Addendum #1

May 7, 2018

SHEET TITLE: CRAWL SPACE DETAIL			CLIENT: DEAF BLIND ONTARIO SERVICES, 17665 LESLIE STREET, UNIT-15, NEWMARKET, ONTARIO, L3Y 3E3.		PROJECT: 86 EARLWOOD DRIVE, PETERBOROUGH, ON	
SEAL: 	DRAWN BY: SANDY	PROJECT #: 17037	Gregg Gordon Architect 516 Hunter Street West Tel. (705) 876-6548 Peterborough, Ontario Fax. (705) 876-9206 K9H 2N1	PLOT DATE: Apr. 26, 18	DWG #:	REV #:
	CHECKED BY: GG	SCALE:				
		DATE: APRIL 2018

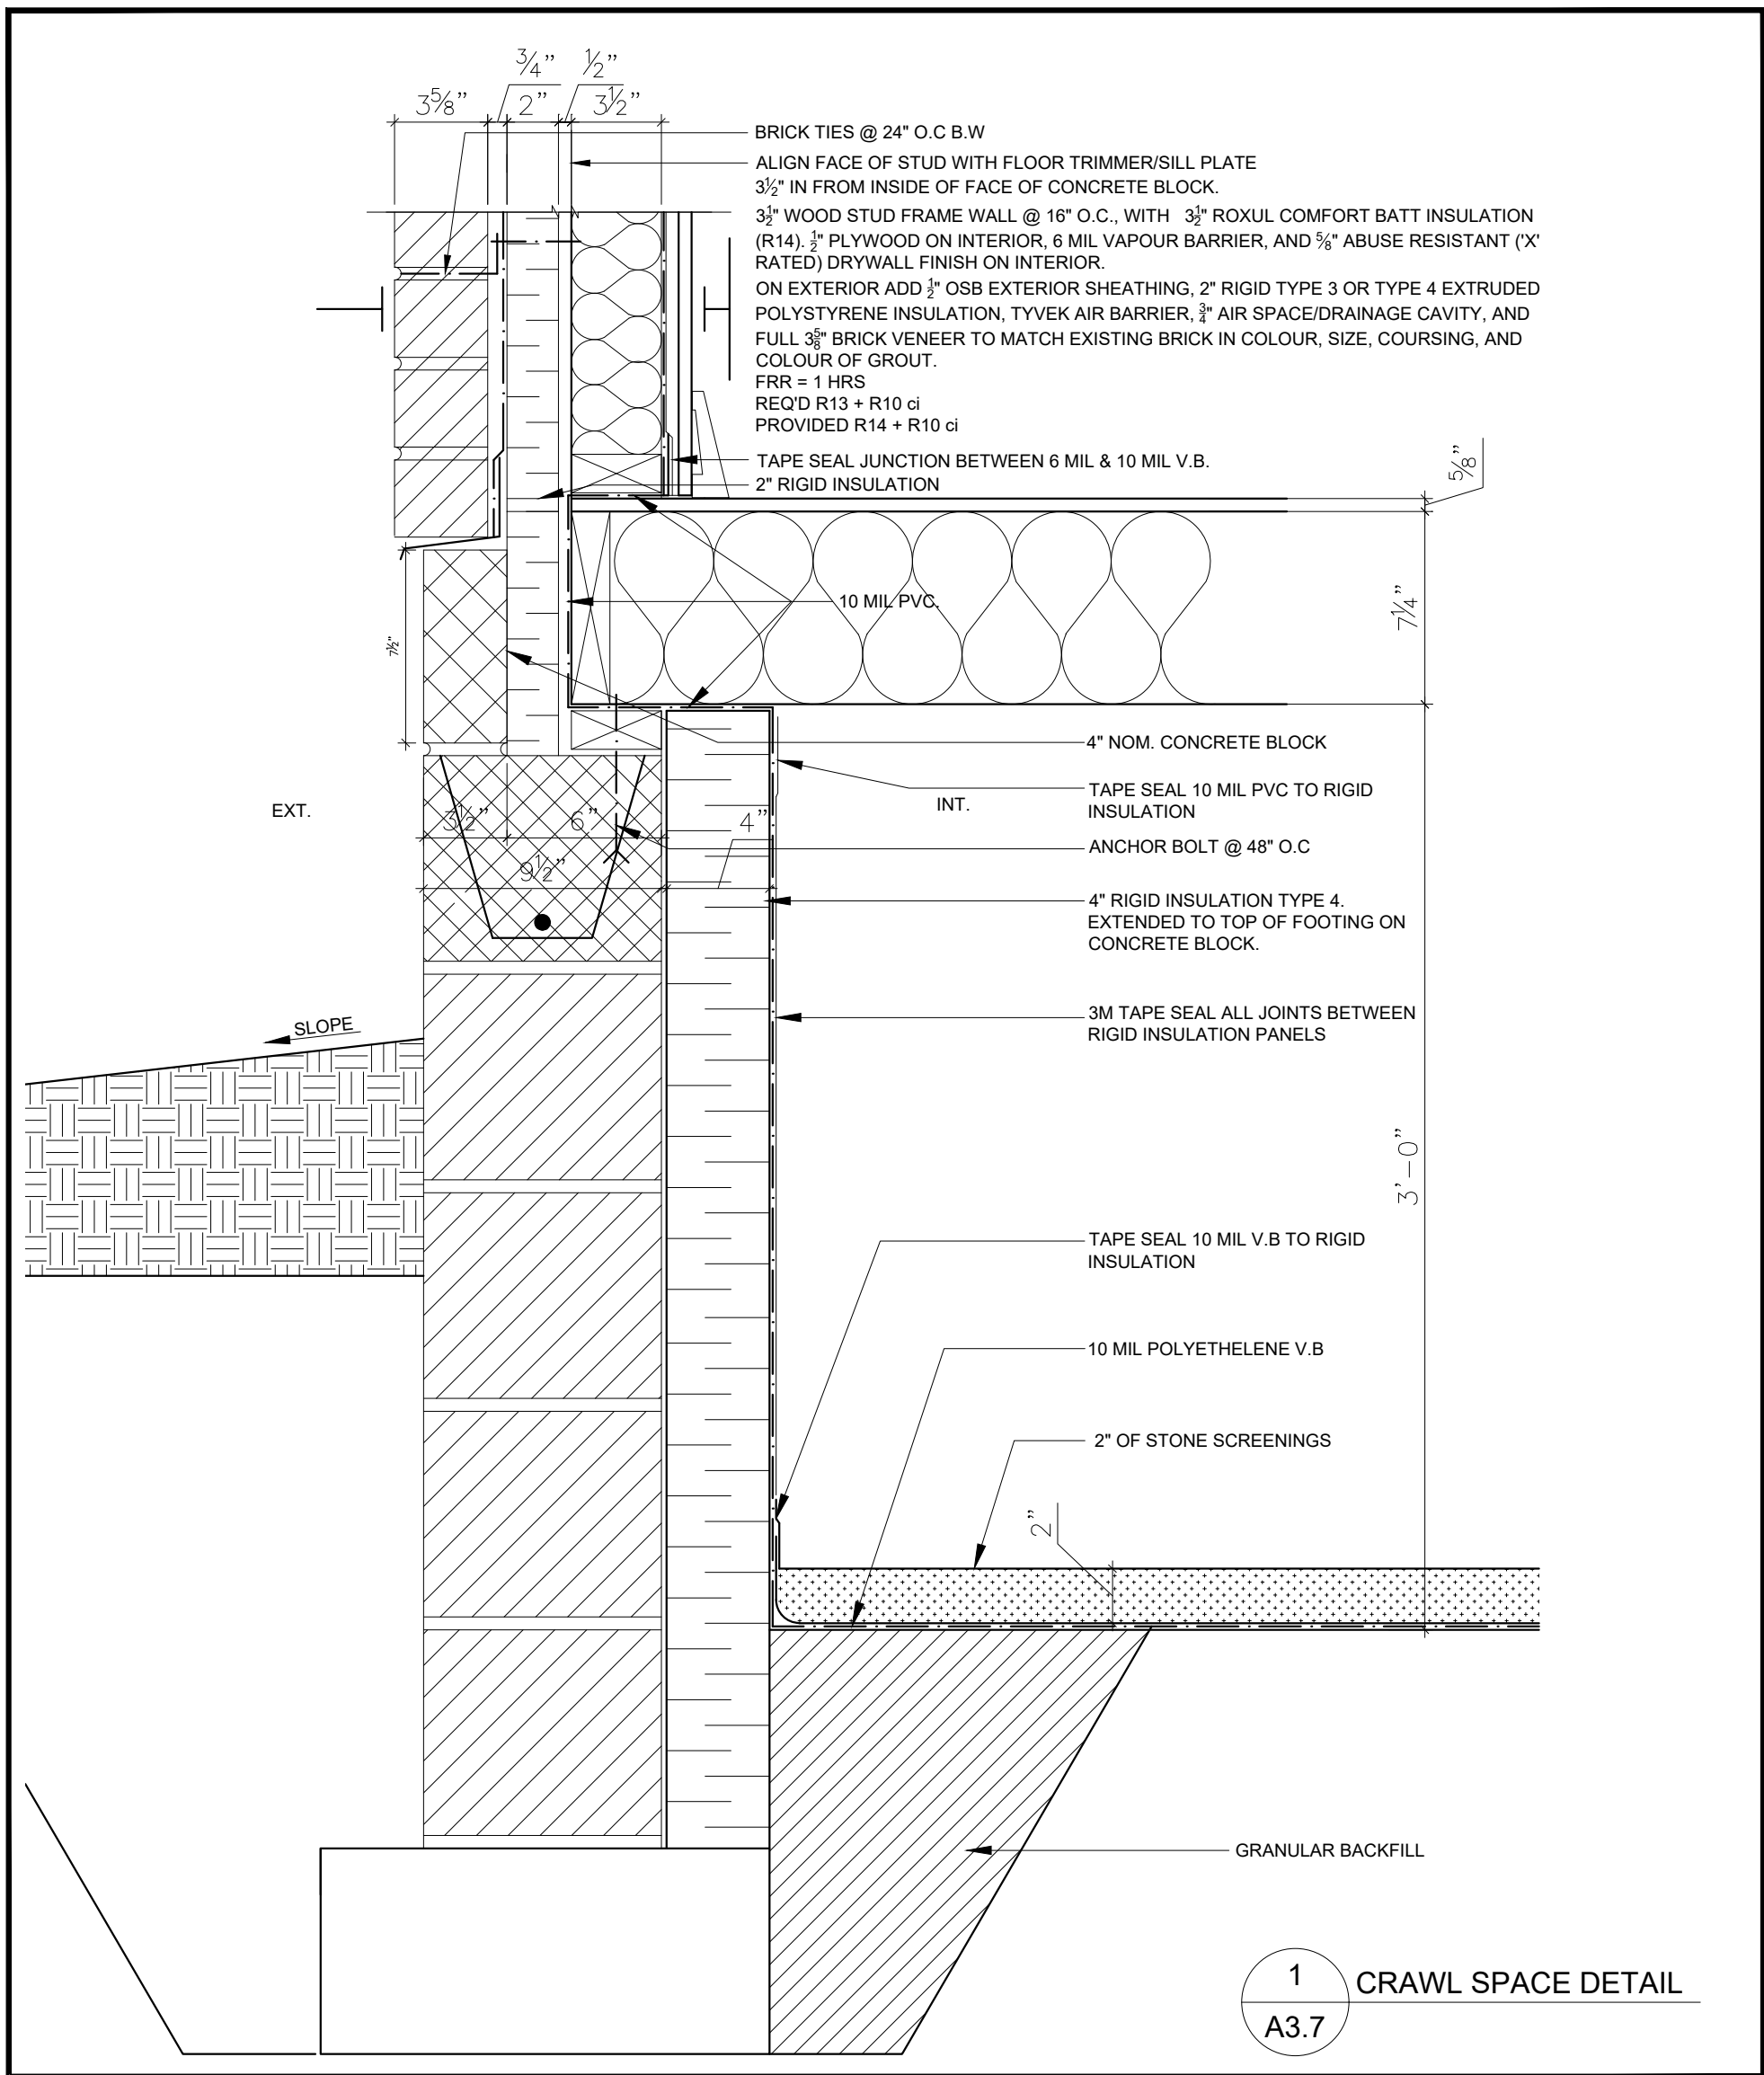
- 1.3 Drawing A3.5, Crawl Space: Provide a 10 mil polyethylene sheet on the floor of the levelled crawl space. Extend the PVC sheet up the side walls approximately 12" and continuously tape seal the PVC to the insulation wall panels. Use this same tape to seal all joints in the PVC material on the ground to create an unbroken vapour seal to prevent moisture from coming up through the ground. Tape seal all vertical and horizontal joints in the insulation wall panels surrounding the Crawl Space. Extend the 6 mil wall vapour barrier from above the main floor level, with a 10 mil V.B. that continues below the bottom plate of the exterior wall framing, down the face of the trim board and back below the joists and down the inside face of the insulation panels, approximately 12", in the Crawl Space. Continuously tape seal the 10 mil V.B. at the top of the insulation wall panels in the Crawl Space to the insulation wall panels. Use the red 3 M tape at all of these taped locations. Cover the Crawl Space floor with 2" of stone screenings across the entire Crawl Space floor area. See attached 8 ½" x 11" Sketch Detail 1 on Drawing A3.7.

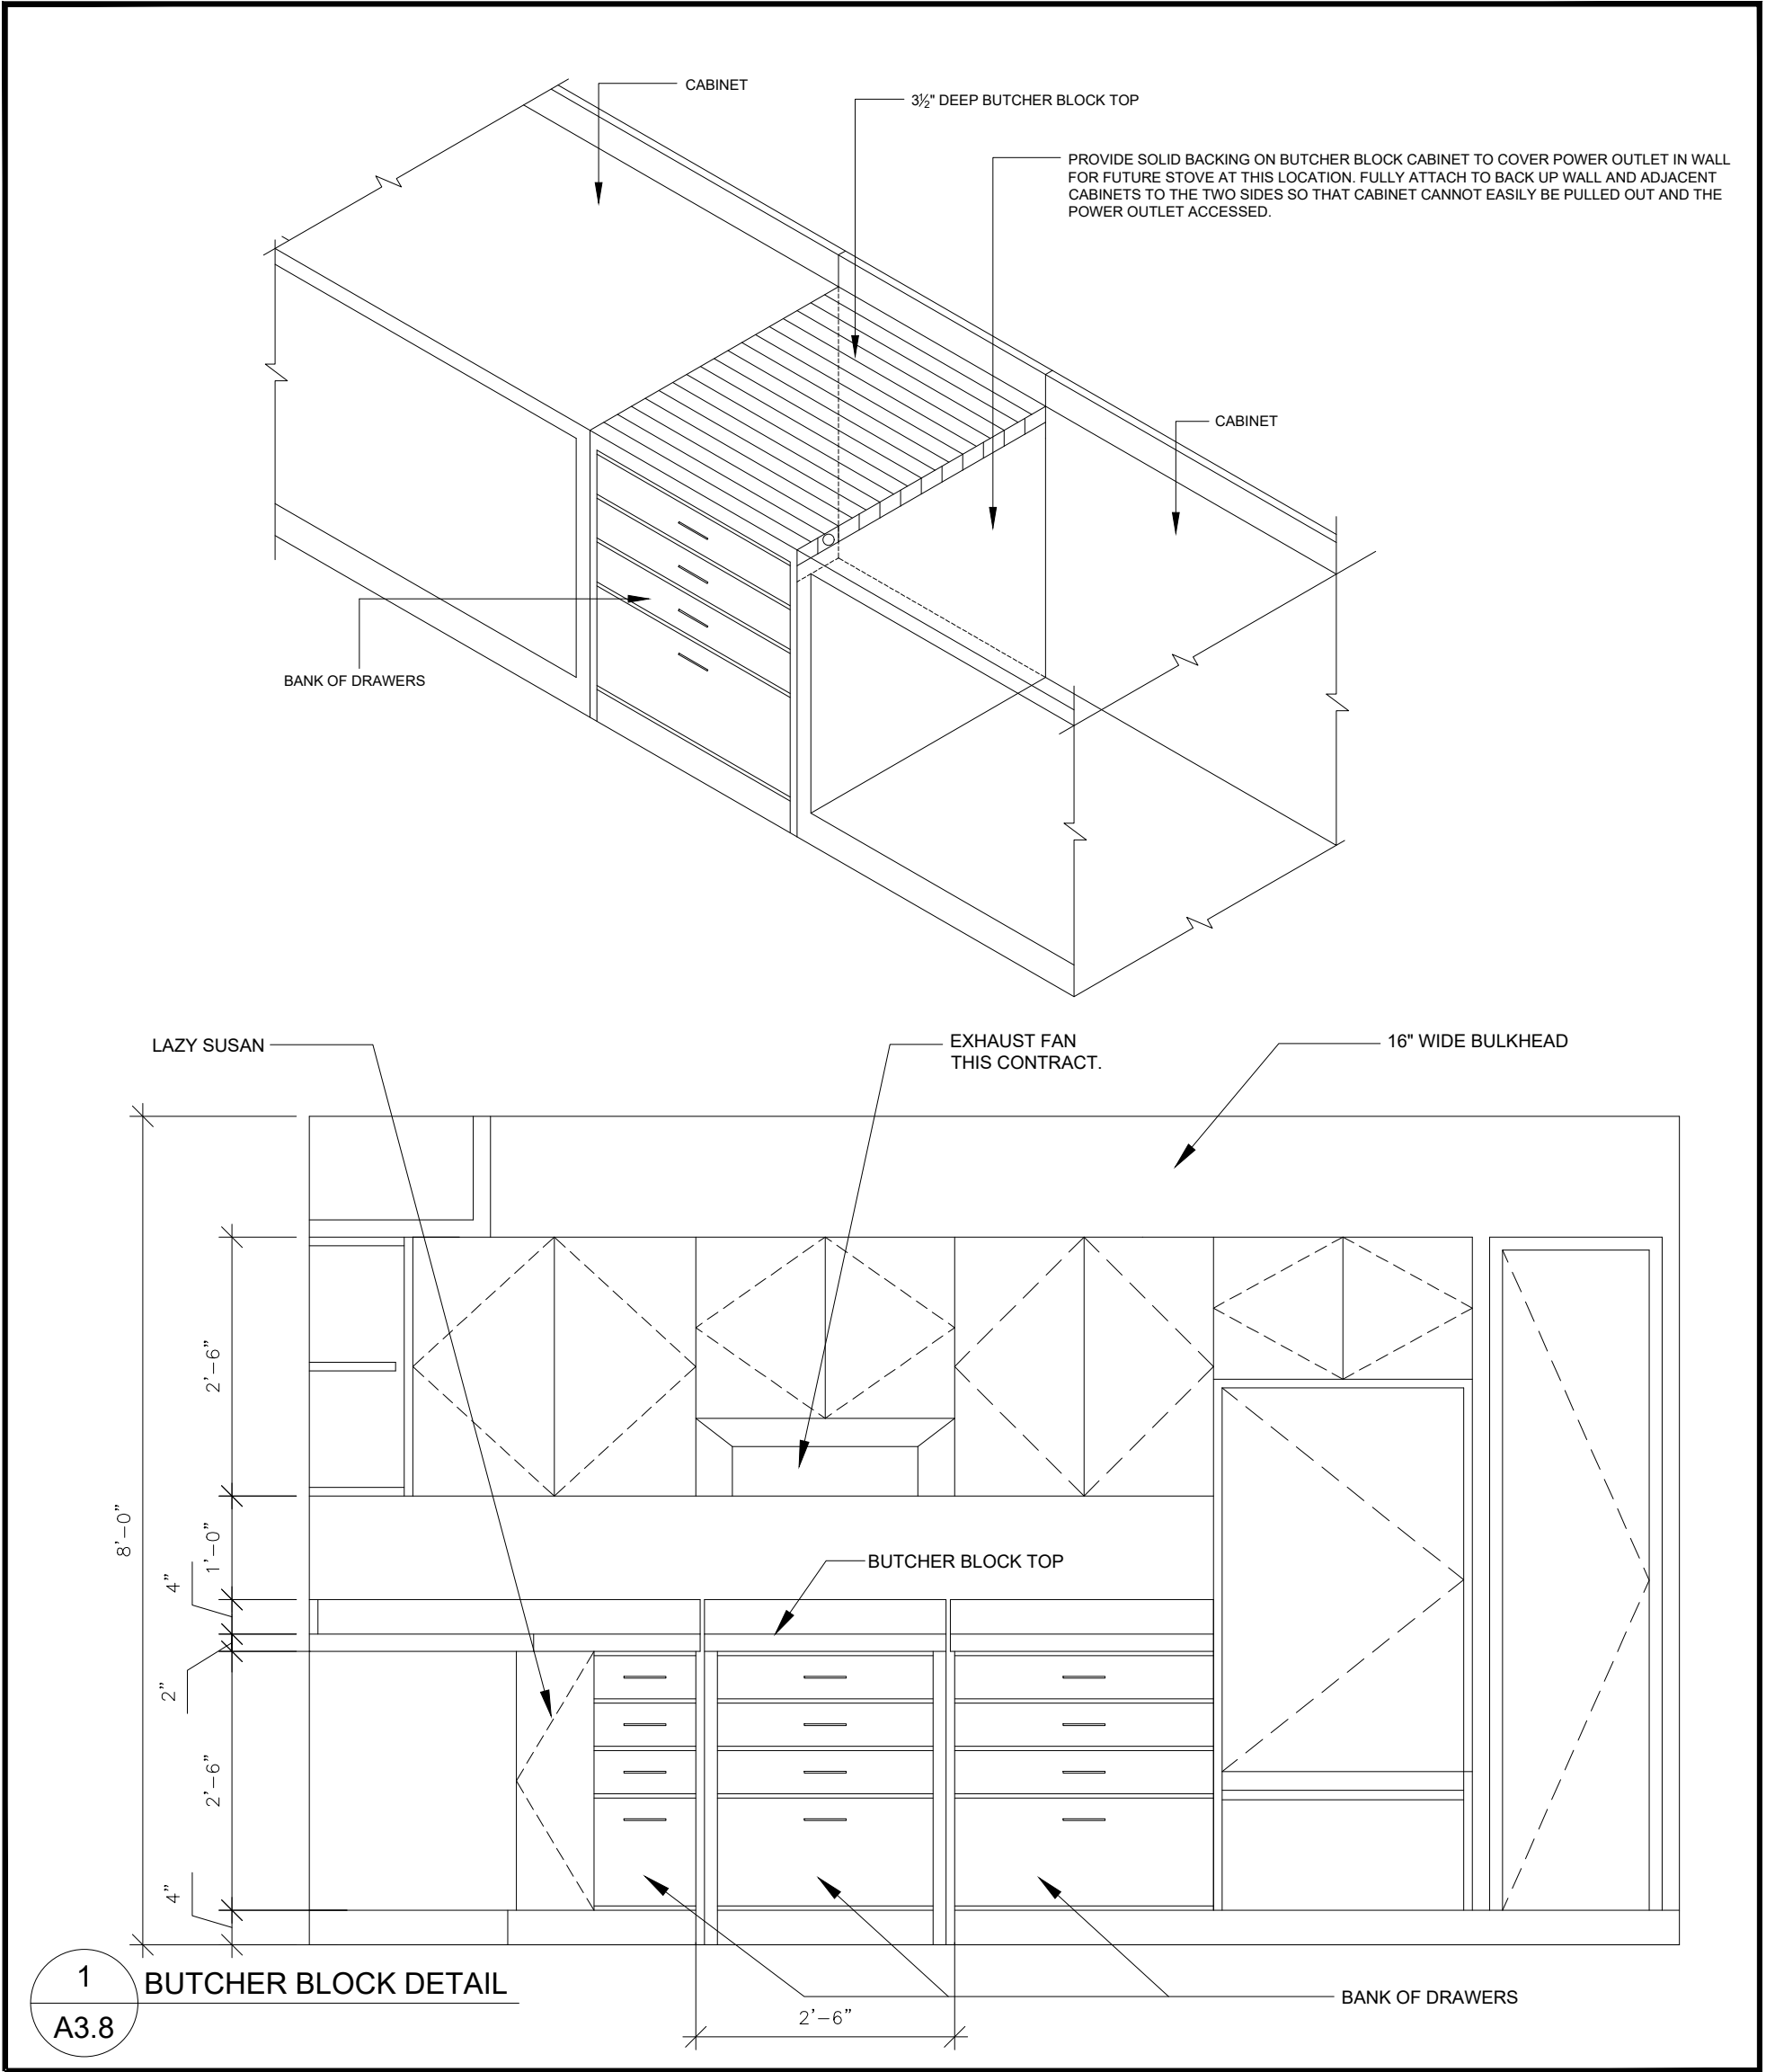
- 1.2 Drawing A1.1, Kitchen Cabinetry Elevation: Replace butcher block cabinet, as shown, with a bank of drawers. See attached 8 ½" x 11" Sketch Detail 1 on Drawing A3.8.
